Interactive comment on “Nitrogen dioxide observations from the Geostationary Trace gas and Aerosol Sensor Optimization (GeoTASO) airborne instrument: retrieval algorithm and measurements during DISCOVER-AQ Texas 2013” by C. R. Nowlan et al.

Received and published: 18 March 2016

We thank Reviewer 2 for helpful comments. In the text below, the reviewer's comments are in italics, followed by our response and edits.

Fig. 1.

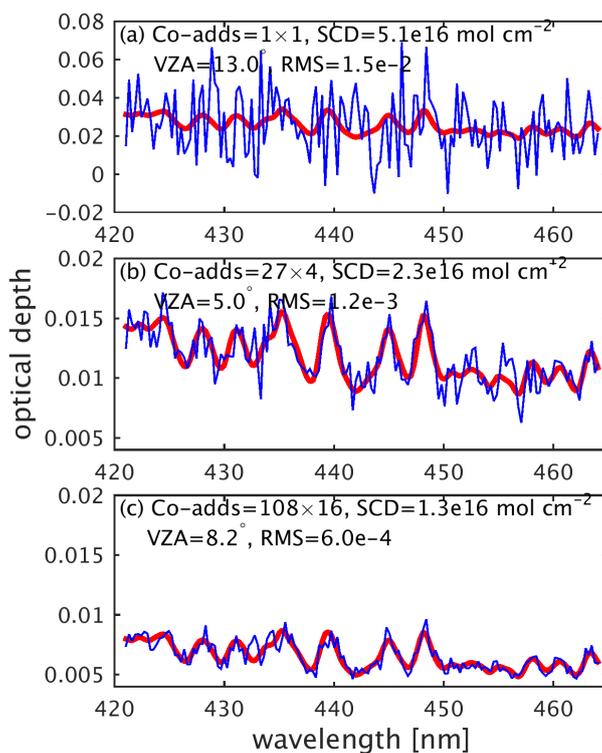
Page 13114 lines 1-3: This RMS is quite high in comparison to other flight campaigns. Could this be improved through co-adding pixels before the fitting of absorbers? Could a typical fit on NO₂ be added in a figure?

Page 13118 lines 7-10: Has this precision been proved? It only applied if the noise is

Gaussian. With the consideration of stray light etc. the square root of n rule does not apply. If the precision has in fact improved could a spectral fit be shown in a figure to highlight this?

These RMS results are at native resolution. The RMS improves with co-adding. We have added the following to the text: "For retrievals using co-added spectra, the mean RMS is $\sim 1.6 \times 10^{-3}$ at 250 m \times 250 m resolution. GeoTASO design requirements were driven by NO₂ fitting at a resolution of 1 km \times 1 km. At this resolution, the mean RMS is $\sim 7 \times 10^{-4}$, which is comparable to previous fitting results in this spectral region (Martin et al., 2002; Chan Miller et al., 2014), and includes some remaining

systematic residuals as well as other residuals which are not necessarily systematic from co-adding inhomogeneous scenes and different wavelength positions and slit functions.” We have now included a figure which shows a typical fit.

We have included text related to this in Section 4.3 and a figure of a spectral fit, as described above.

Figure 1: Sample NO₂ spectral fits showing observed (blue) and simulated (red) optical depths from spectra collected over South Houston (29.70 N, 95.24 W) on 13 September 2013 at 10:46 LT, SZA = 44.1 for a) native resolution (no co-adding); b) 250 m × 250 m resolution (27×4 co-adds); and c) 1 km × 1 km resolution (108×16 co-adds).
